# Memorandum

Woods  
 [REDACTED] – Technical Director  
 W-REF: P25-534  
 19 December 2025

Item	Description
Project	Delmore Residential Development, Ōrewa
Client	Vineway Ltd
Site Area	~109 hectares
Lots Proposed	~1,250
Location	53A, 53B & 55 Russell Road; 88, 130 & 132 Upper Ōrewa Road
Existing Land Use	Pasture, pine plantation, covenanted bush
Zoning	Future Urban

STORMWATER  
EXISTING NZTA CULVERT  
UPGRADE PLAN

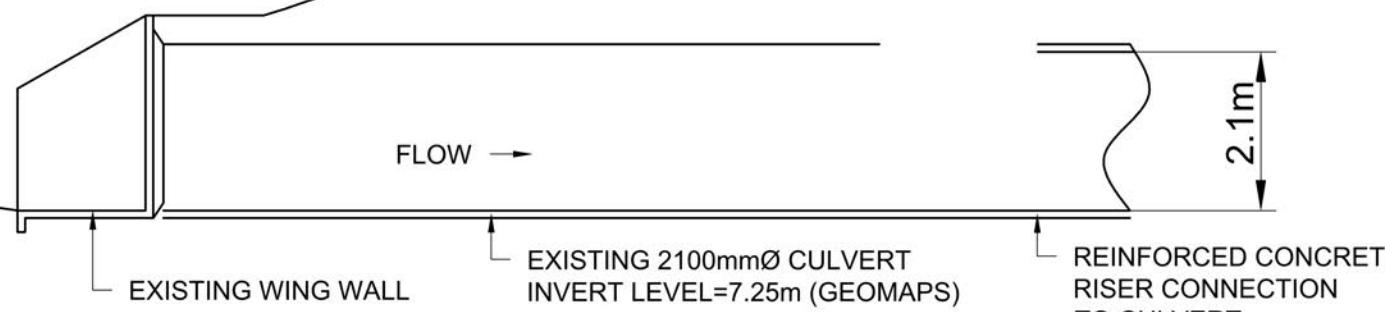
The consultation focused on NZTA's primary concern relating to the potential risk of culvert blockage and the resilience of the motorway embankment. Specifically, NZTA sought assurance that any changes in runoff frequency, velocity, and volume directed towards the embankment would not increase the risk of scour, erosion, or structural vulnerability at the culvert inlet and transition zone, where hydraulic effects are expected to be greatest.

The proposed development has been assessed against various flood scenarios. A plot illustrating the modelled flood levels is provided in Appendix B – NZTA Culvert Flood Levels.

The modelling results, summarized in **Table 3**, demonstrate that flood level increases are considered negligible to less than minor in the context of the motorway's elevation and do not increase the risk to the embankment.

- **100-Year Event:** The post-development flood level (16.80mRL) is lower than the pre-development level (17.10mRL). This is because the proposed culverts provide attenuation in the post-development scenario, reducing downstream flood elevations. These culverts are designed to pass smaller events/flows forward.
- **Full Blockage Scenario:** Even under a hypothetical full blockage scenario (100-year event), the modelled flood level is 21.50mRL, which leaves approximately 5.5m of freeboard to the motorway.

The risk of highway overtopping has never been raised as a concern. Rather, my concern relates to the resilience of the highway embankment due to the increased frequency, velocity, and volume of runoff directed towards the embankment—particularly at the transition from the natural stream to the culvert inlet, and at the ground interface beyond the culvert headwall. Specifically, this relates to the potential risk of scour and erosion at the transition and inlet where velocities and risk to our system resilience here will be highest.

That said, I am comfortable that the proposed change in water depths is unlikely to materially alter the existing risk profile at our highway system. It may be appropriate, however, for the monitoring regime to include a condition that, should accelerated scour or erosion be observed by mutual monitoring (up to the time that the development is fully built out, and the site is stabilised), that a requirement could be triggered to install a relief inlet riser consistent with NZTA P46 standard design and/or additional embankment interface reinforcement/resilience measures could be proposed by the project. <https://nzta.govt.nz/assets/resources/stormwater-specification/P46-Stormwater-management-and-minor-stream-diversion-design-guidance-document.pdf>

Based on the flood modelling undertaken by McKenzie and the substantial reduction in blockage risk associated with the change in land use, it is proposed that a secondary inlet is not required.

Therefore instead of a secondary inlet, it is proposed managing the temporary blockage risk through active maintenance and monitoring of the culvert via the following approach:

- **Consent Condition:** A consent condition will be required to mandate a comprehensive Management Plan to address potential blockage from any residual slash or debris, particularly during the construction phase.
  - The monitoring regime to include a condition that, should accelerated scour or erosion be observed through mutual monitoring prior to full site stabilisation, a requirement could be triggered to install a relief inlet riser in accordance with NZTA

Based on the consultation undertaken and NZTA's feedback, NZTA is satisfied with the proposed approach to managing culvert blockage risk, monitoring potential scour and erosion, and the assessment of flood effects. NZTA agrees that the proposed development does not materially alter the existing risk profile or resilience of the highway embankment and that any residual risk can be appropriately managed through the agreed consent condition and monitoring & management measures.
